DEVELOPMENT APPLICATION ASSESSMENT REPORT

Application Number:	DA2025/0172
----------------------------	-------------

Responsible Officer:	Olivia Ramage
Land to be developed (Address):	Lot 3 DP 206600, 9 Rowan Street MONA VALE NSW 2103
Proposed Development:	Alterations and additions to a dual occupancy (attached)
Zoning:	R2 Low Density Residential
Development Permissible:	Yes
Existing Use Rights:	No
Consent Authority:	Northern Beaches Council
Land and Environment Court Action:	No
Applicant:	Leigh Graham

Figure 1 - Survey of 9 Rowan Street

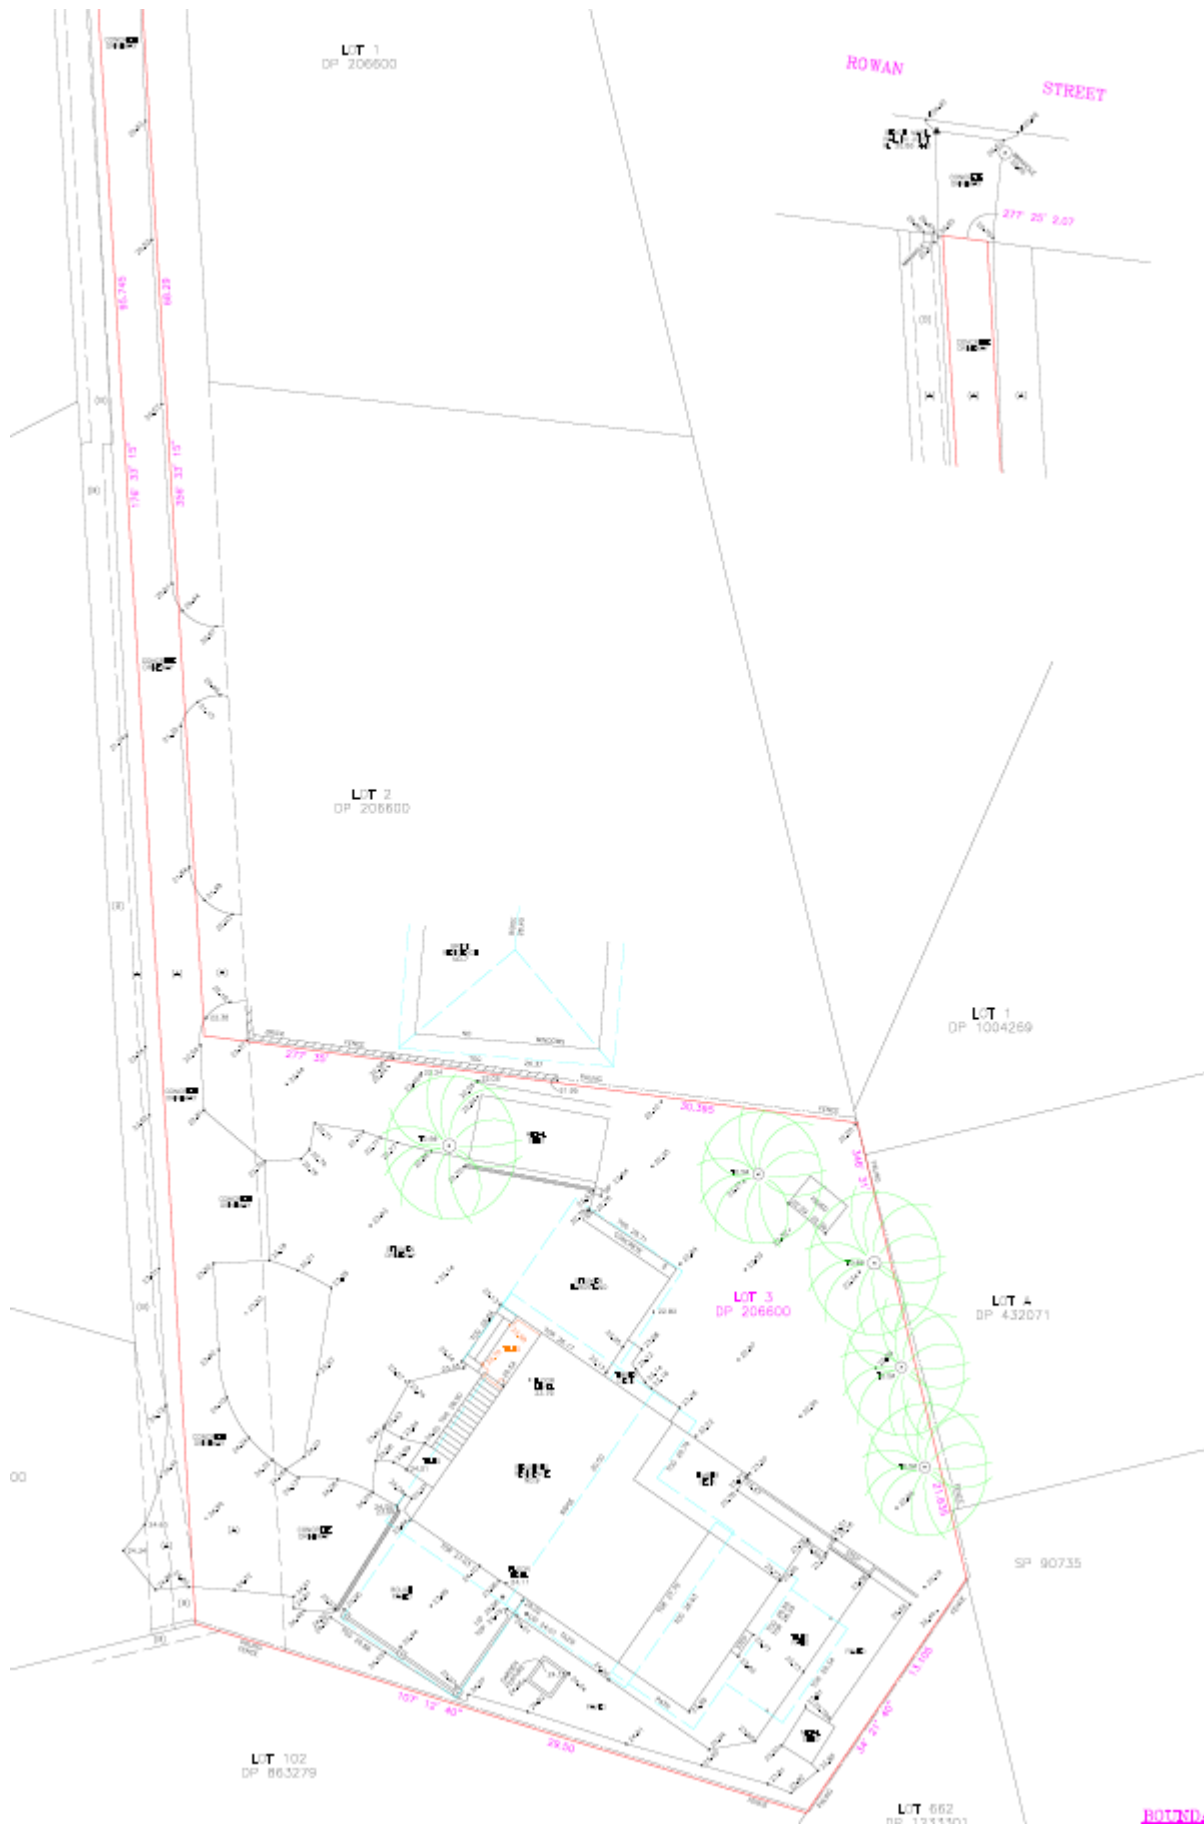
The submission raised concerns that the survey indicates that the boundary of the subject site includes the entire shared carriageway and access to 11 Rowan Street. It was understood by the submitter that the correct boundary aligns with the dotted line adjacent to Lot 3. The submission requests confirmation that the survey and plans accurately reflect the property boundaries.

They survey provided has been prepared and signed by a registered surveyor and notes that boundaries have been determined which is in accordance with Council's DA Lodgement Requirements. A review of the survey and Deposited Plan (DP) has confirmed that the boundaries are appropriately delineated as shown below. As shown in the survey and DP, the shared driveway sits within the boundaries of Lot 3 but is a right of carriageway appurtenant to Lots 1, 2, 4 and 6. The dotted line adjacent to Lot 3 contains an easement over Lot 4 for services and to drain water.
